Field Report: Findings from a brief field assessment of selected wetlands within a 500m radius of the N2 Wild Coast Toll Highway Project between the Msikaba and Mthentu bridges.

Compiled by Steven Ellery (Pr.Sci.Nat – Ecology, MSc - Geography)

Figure 2 Potential compliance issues in relation to the development and associated wetlands. The numbers correspond to the numbers in Table 2 above.

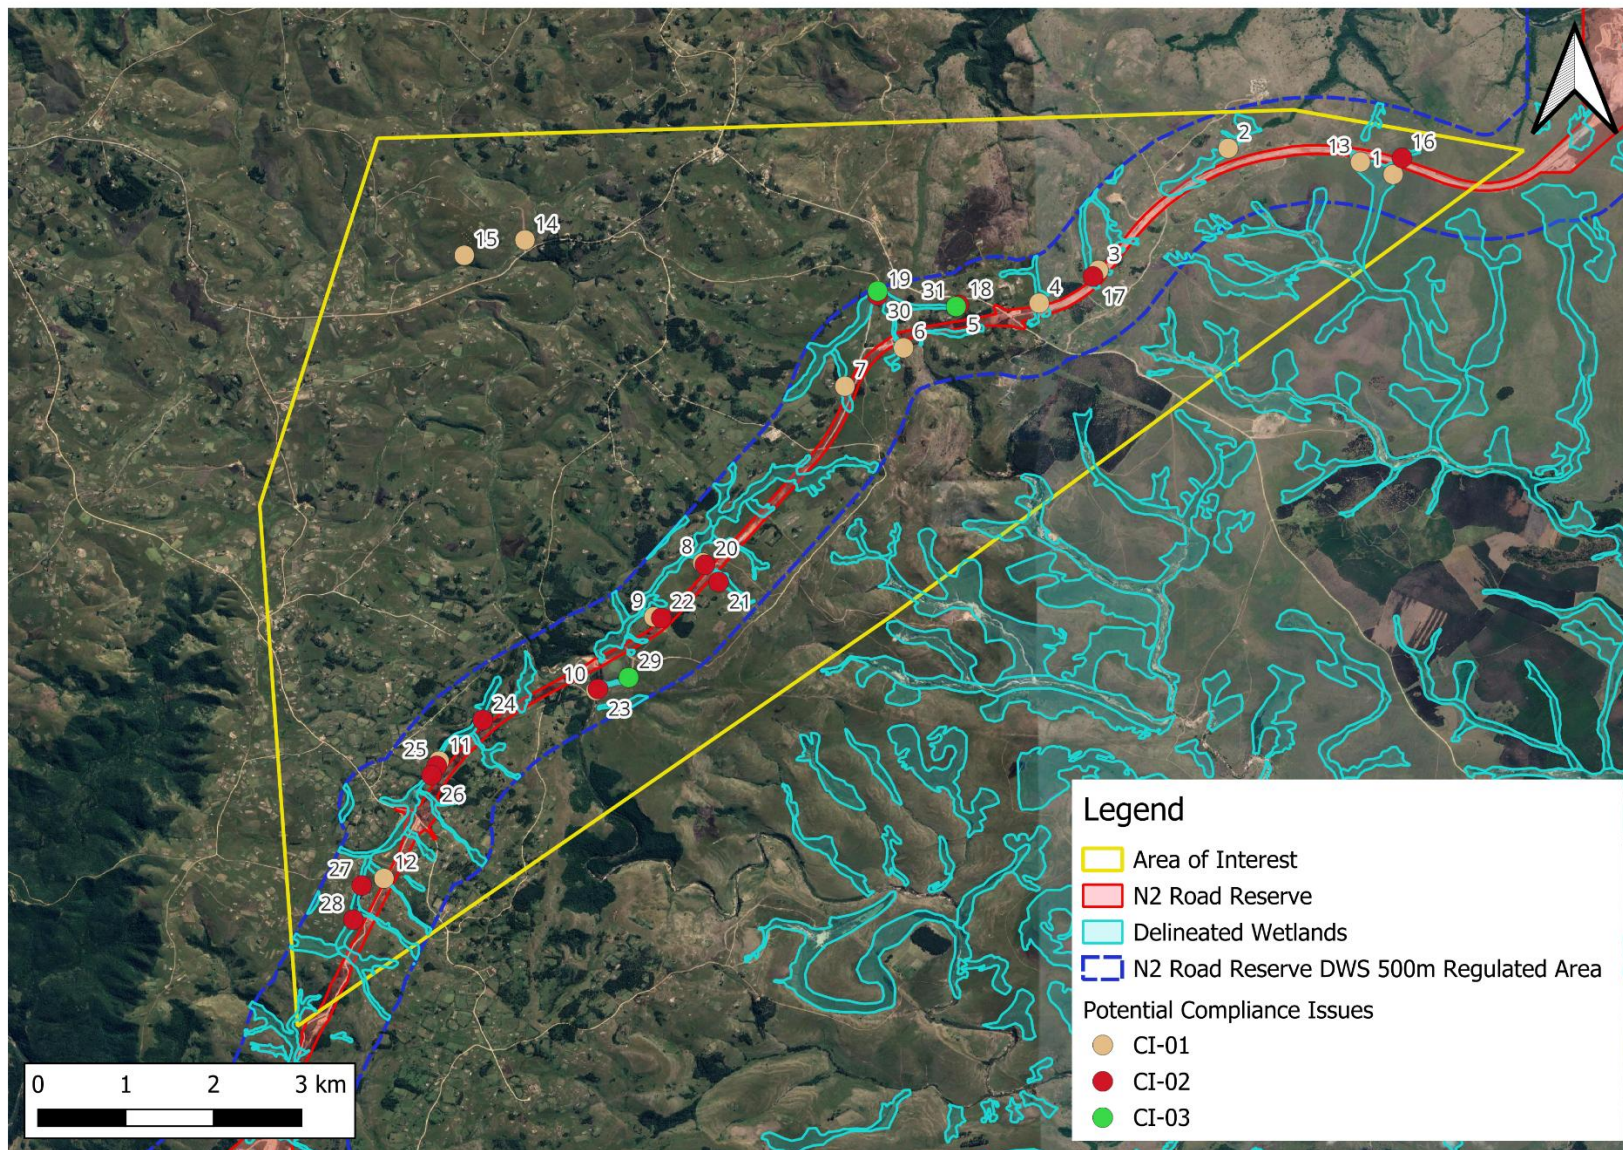
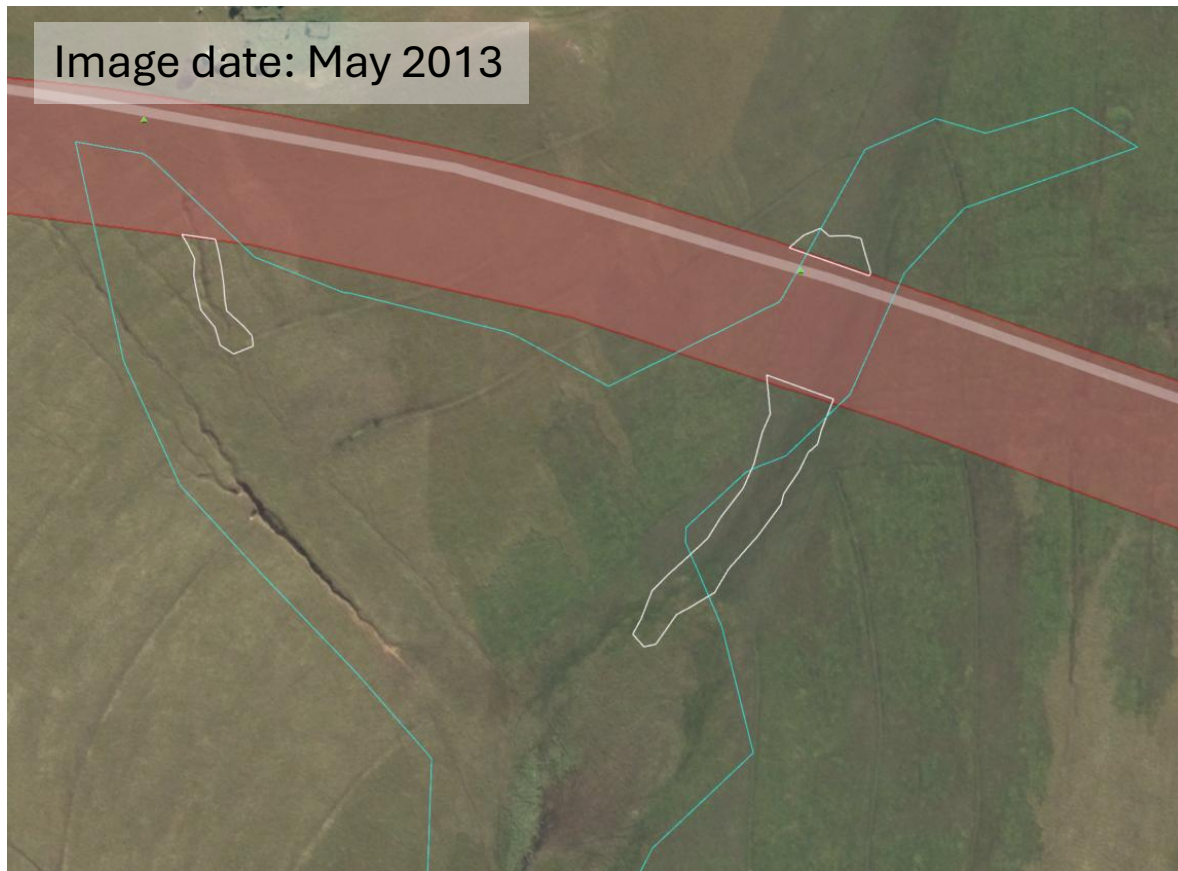
The findings from the field visit are initially categorised by their ‘type’ of impact, and then specific examples of these impacts are documented in more detail below. There are three potential compliance issues (CI’s) that were noted within the study area with a total of 15 noted instances of CI-01, 13 noted instances of CI-02 and three noted instances of CI-03 (Table 2 and Figure 2). The main claim associated with each CI is documented below:

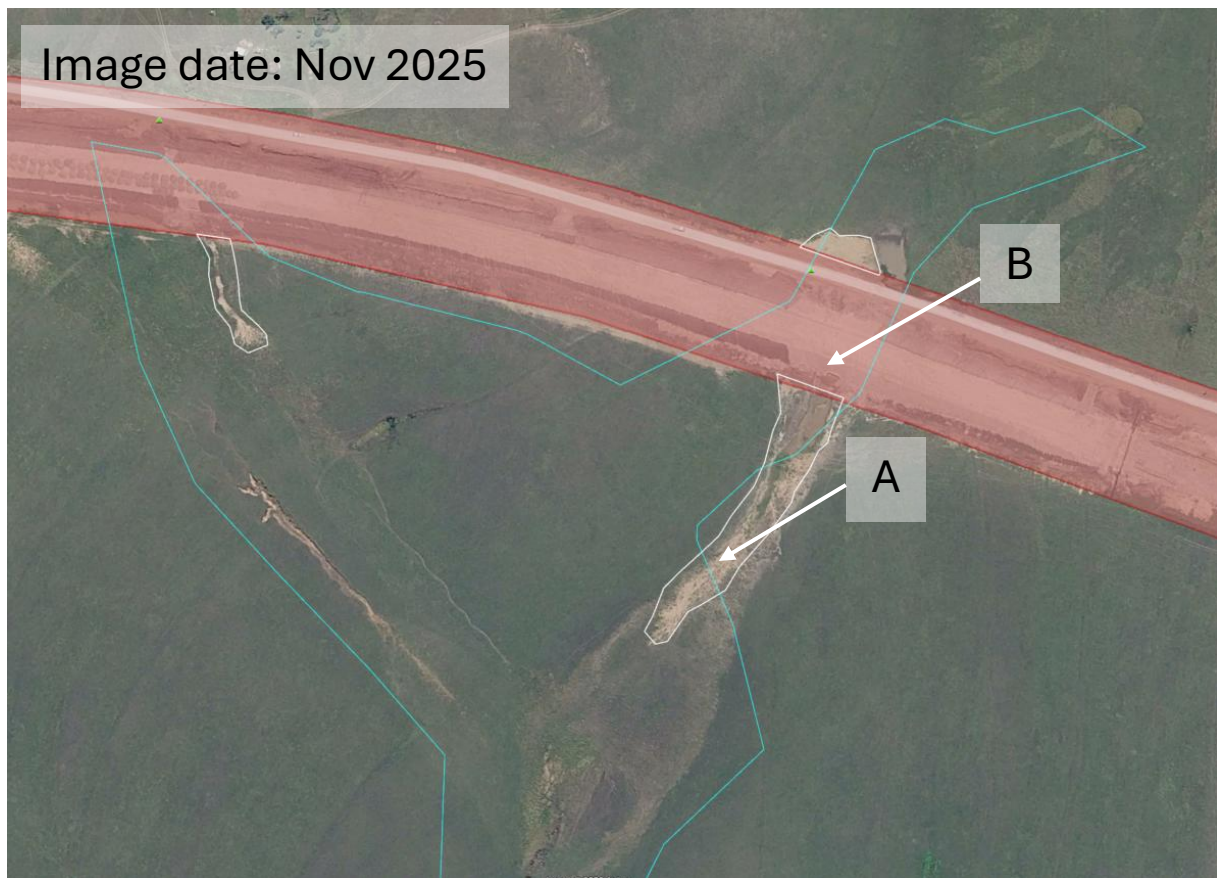
A total of 15 instances of sedimentation within watercourses were observed downstream of active construction areas associated with the N2 Wild Coast Toll Highway development. Sediment-laden runoff from exposed and disturbed construction surfaces appears to have entered multiple aquatic ecosystems as a result of inadequate stormwater management, insufficient erosion control, and poor runoff containment. An example of this is shown in Figure 3 below, illustrating CI numbers 1 and 13. The first map shows an image of the wetlands (outlined in blue) in May of 2013, prior to the development of any N2 related infrastructure (shown in the red polygon). The second map shows the same area, but in November of 2025. The white outlines indicate the approximate extent of the sediment deposition, which amounts over 5000 square meters or half a hectare.

Figure 3 Comparison of a headwater seep and unchannelled valley bottom wetland in May 2013 and November 2025. The blue outlines illustrate the extent of the wetlands, the red polygon illustrates the N2 road reserve and the white polygons illustrate the approximate extent of the sediment deposition. The labels of A and B in the second map correspond to the location where photos A and B in Figure 4 below were captured from.

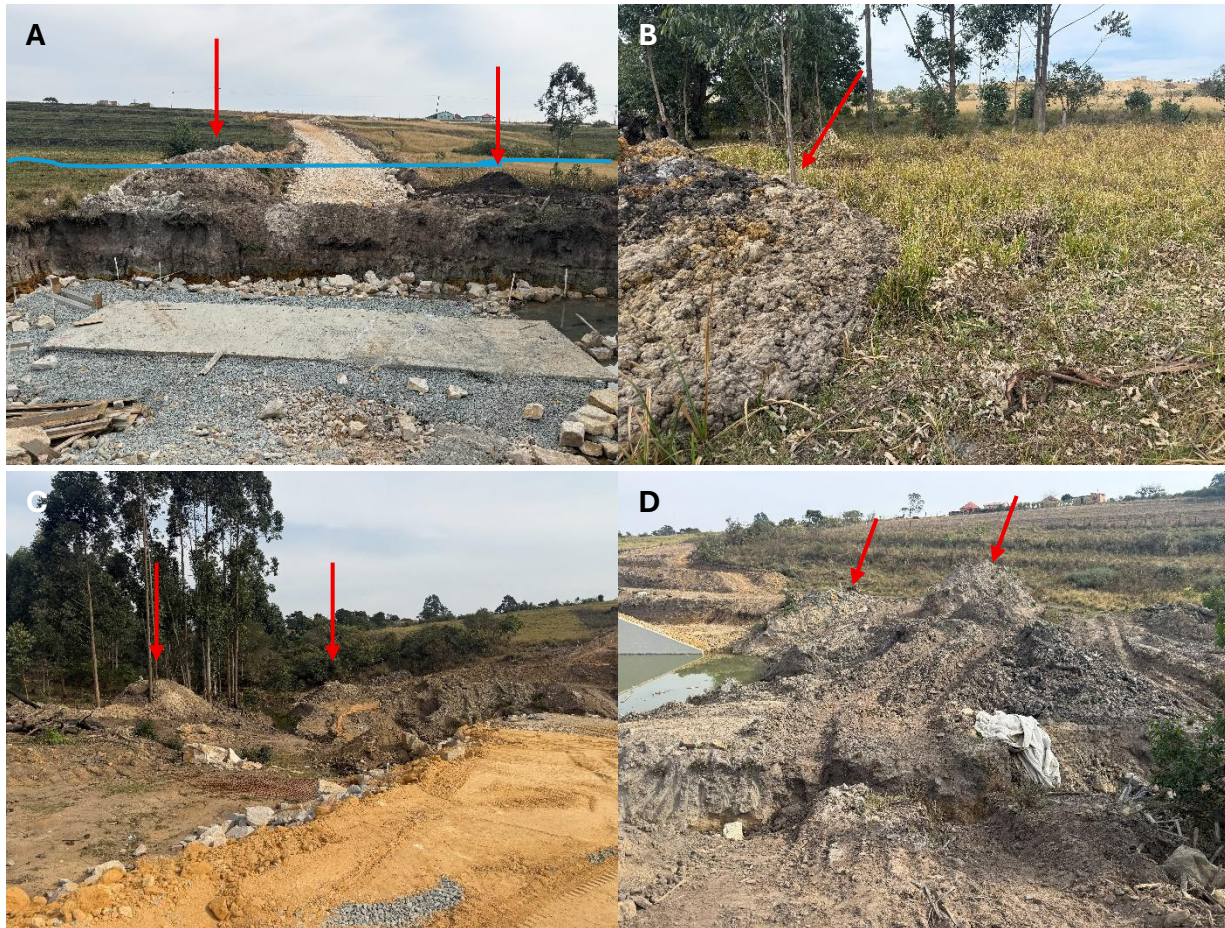
A key concern relates to the stockpiling of excavated spoil material and imported construction material within watercourses and directly adjacent to wetland and riparian areas. In multiple locations, stockpiled material was observed within sensitive aquatic environments without evidence of adequate erosion protection or containment measures (Figure 6). This is of particular concern given the increased risk of sediment mobilisation during rainfall events and the resulting downstream degradation of aquatic ecosystems.

Figure 6 A) An access road crossing a channelled valley-bottom wetland. The blue line indicates the approximate boundary of the wetland and the red arrows indicate stockpiles located within the wetlands (CI number 28). B) Also shows CI number 28, although indicating another stockpile dumped within sensitive wetland vegetation such as *Dissotis canescens*, *Phycnostachys* sp, *Cyperus latifolius* and other species. C) An access road crossing a riparian habitat with extensive stockpiling of material within the riparian corridor with little to no sediment control measures (CI number 25). D) Downstream of CI number 25 is CI number 26 as depicted in this photograph. Find coordinates of all photographs in Appendix A.

The observed stockpiling appears inconsistent with multiple provisions of the project Environmental Management Programme (EMP). Clause 20 explicitly states that no construction camps, dumping, or stockpiling of construction material shall be allowed in or close to wetlands and other watercourses, while Clause 8 further states that no materials shall be stockpiled in any wetland areas. Clause 5 additionally requires all temporary stockpile areas to be approved and demarcated, and stipulates that stockpiles must be constructed and maintained to avoid erosion and contamination of the surrounding environment, including preventing material from spilling into rivers and drainage lines.

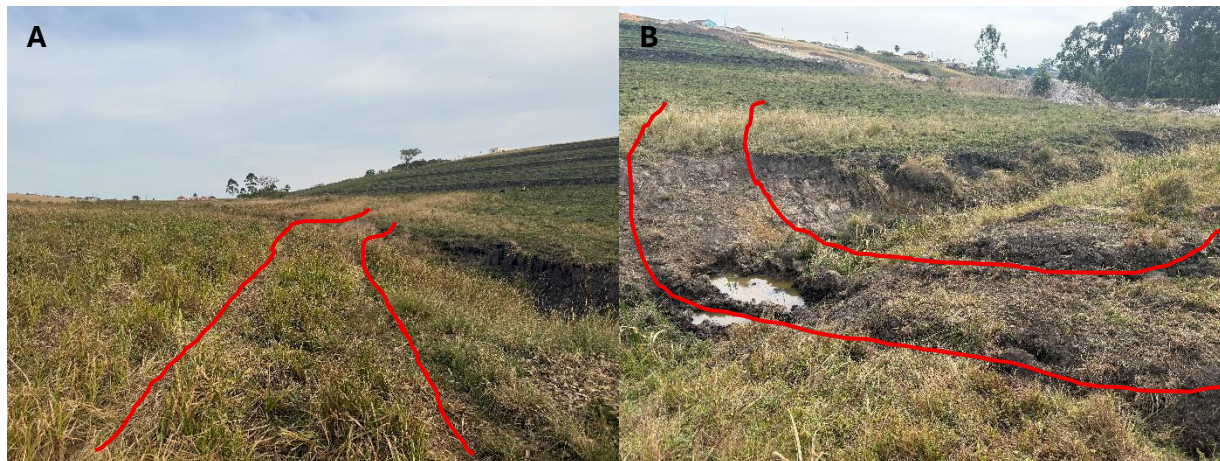
Further concerns arise from evidence of heavy construction vehicles, including tracked excavators, moving through intact wetland areas beyond the immediate crossing footprint. This activity has caused substantial physical disturbance, including vegetation destruction,

soil compaction, rut formation, and surface deformation (Figure 7). Such disturbance has the potential to impair wetland hydrological functioning by reducing infiltration, altering surface flow pathways, increasing runoff concentration, and reducing the natural buffering capacity of wetlands.

Figure 7 A) Red lines indicate the path taken by a large tracked vehicle (likely an excavator) through an intact portion of wetland to cross the channel pictured in B) (CI number 28). B) Red lines indicate the path taken by the large tracked vehicle across the channel. Not extensive disturbance and vegetation removal as a result of the excavator having to turn to cross the channel at right angles. Find coordinates of all photographs in Appendix A.

This disturbance appears inconsistent with Clause 20 of the EMP, which explicitly states that no activities shall take place outside demarcated construction areas and that disturbance to environmentally sensitive areas must be avoided. The clause further requires that the construction servitude through wetland areas be kept to a minimum. Based on site observations, the extent of disturbance in certain areas appears to exceed the minimum footprint reasonably required for crossing construction.

Figure 8 CI number 21 is indicated by the pink polygon and CI number 8 is indicated by the grey polygon. The area within the pink polygon has been completely cleared, with no further work done on it.

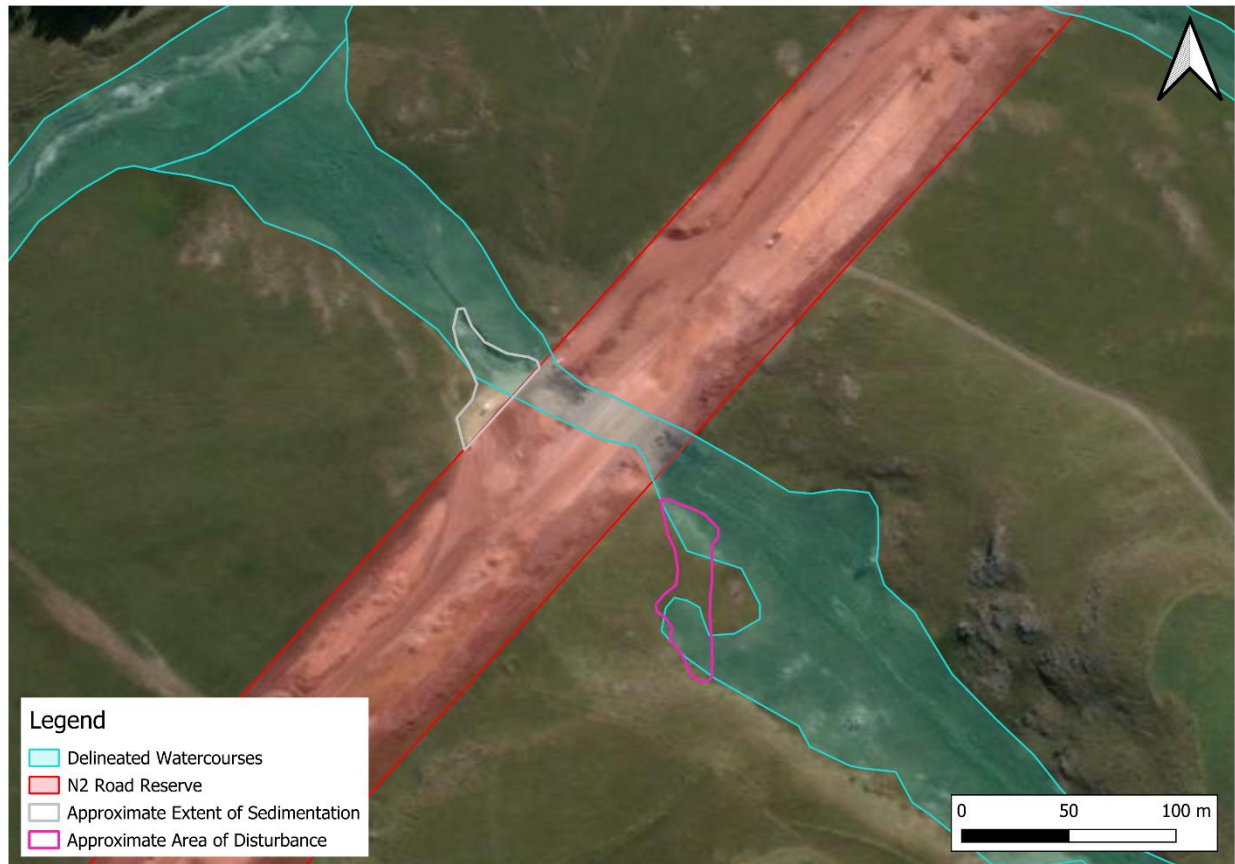
A further concern relates to the unnecessary clearing of natural vegetation within sensitive aquatic habitat. In one observed instance, a large area of vegetation was cleared on a steep slope within a seep wetland for no apparent or clear construction-related purpose (Figure 8). The extent and location of this clearing raise significant concerns regarding whether disturbance was appropriately minimised and restricted to the footprint strictly required for construction activities. The location of the clearing within a steep seep wetland is of

particular concern due to the ecological sensitivity of these systems and their susceptibility to hydrological disturbance, erosion, and channelization (Figure 9A). Vegetation removal in such areas may reduce slope stability, increase runoff concentration, accelerate sediment mobilisation, and impair the wetland's natural hydrological functioning (Figure 9B). Where such clearing was not strictly necessary or appropriately authorised, it may constitute further evidence that the construction footprint has not been adequately minimised in accordance with EMP and Aquatic EMPr requirements.

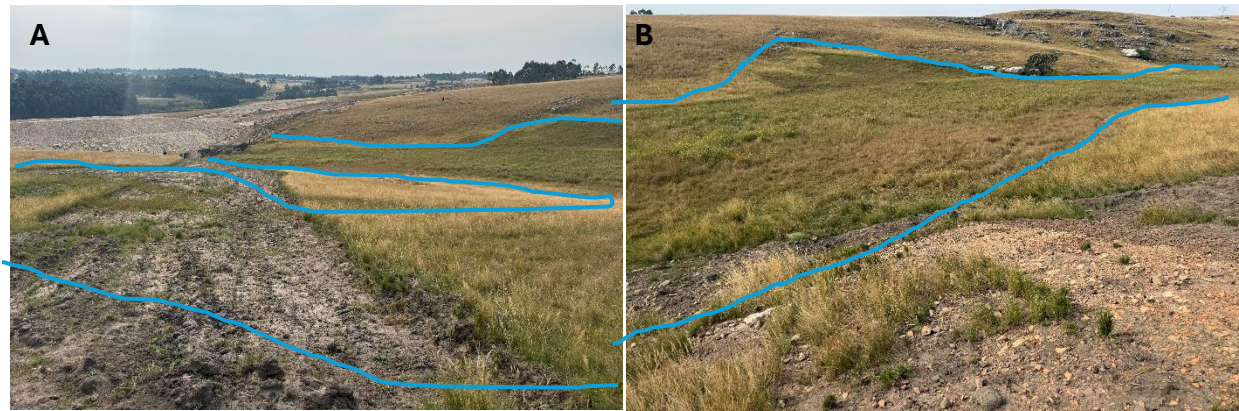
Figure 9 Photographic evidence of CI number 21 as shown in Figure 8. A) Shows the cleared area from the south looking towards the valley bottom wetland, with the approximate wetland extent shown by the blue lines. B) The valley bottom wetland shown by the blue lines with some sediment having washed from the cleared area into the valley bottom. Find coordinates of all photographs in Appendix A.

This clearing appears inconsistent with several provisions of the project Environmental Management Programme (EMP). Clause 2 (Design Phase: Sensitive Areas) requires that vegetation clearing be minimised and restricted to the area required for road construction purposes only. Clause 10 (Design Phase: Access/Haul Roads) further states that, where access roads are required outside the road reserve, vegetation clearing may only occur following written approval from the Engineer, with input from the Project Environmental Manager (PEM) and/or Environmental Control Officer (ECO). Clause 3 (Construction Phase: Site and Construction Camp Clearing) additionally requires that, prior to clearing natural vegetation, the Contractor submit a plan of action and Method Statements to the Engineer, PEM, and ECO for approval.

Figure 11 The captured water uses overlaid with the delineated wetlands. Note the general authorisation for the wetland in the centre of the map states that it is 'Not Crossed'. However, as seen in the map, there is a large road directly through the wetland (CI number 29).

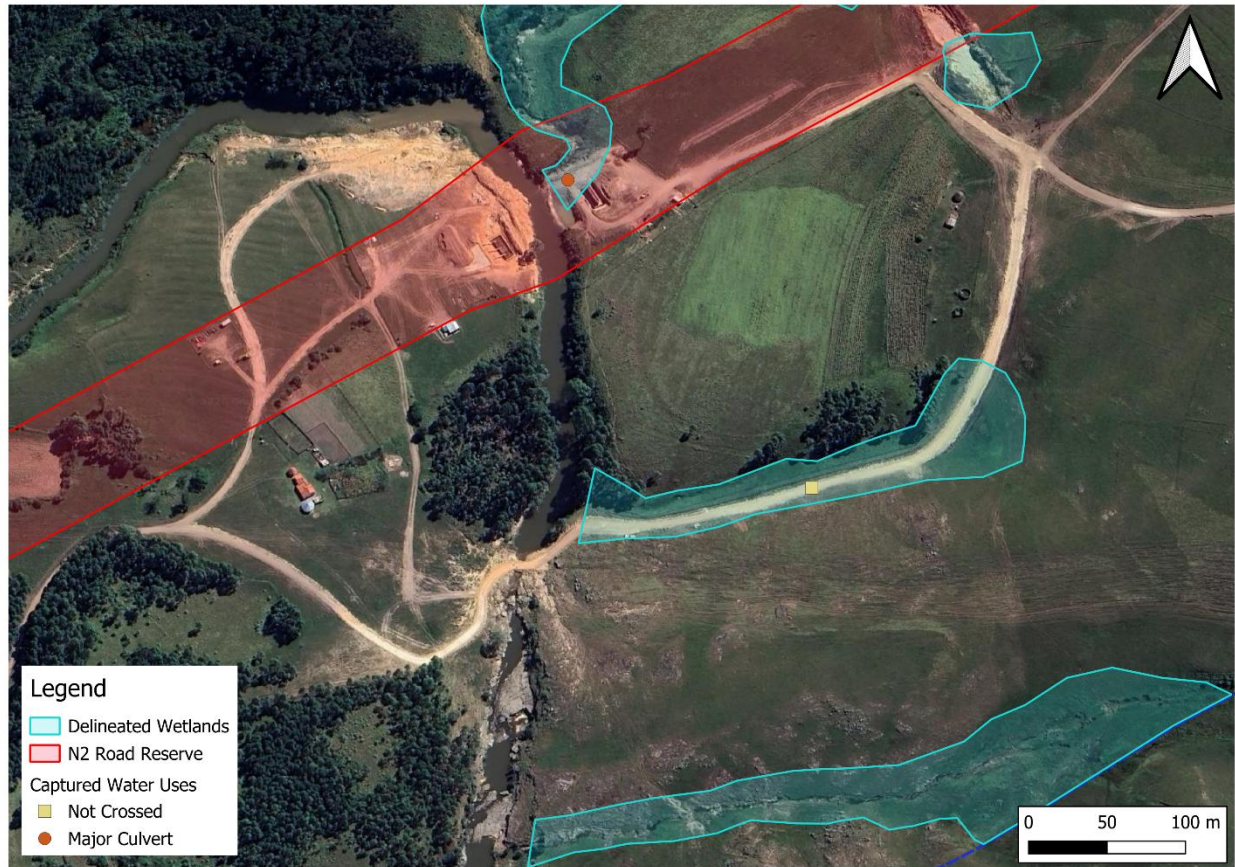
The spatial assessment identified several smaller access roads that appear to cross watercourses but do not correspond with the currently available authorised crossing locations. Of particular concern, two access roads crossing watercourses were identified that are not reflected in either the publicly available authorisation documents or the February 2025 EMC access road map, suggesting that these crossings may represent previously unidentified or unplanned access routes. As shown in Figure 11, an access/haulage road has been constructed through a small seep wetland and a larger river. Cross referencing this location with the coordinates contained within the General Authorisations documents, the authorisation states that the wetland is 'Not Crossed'. Furthermore, this access road is not shown on the access road map in Figure 10, meaning that, as far as the public knows, there is no authorisation for this road through these watercourses. It is noted that this road did not exist in May of 2022, but it appears in the Google Earth image from March of 2024.
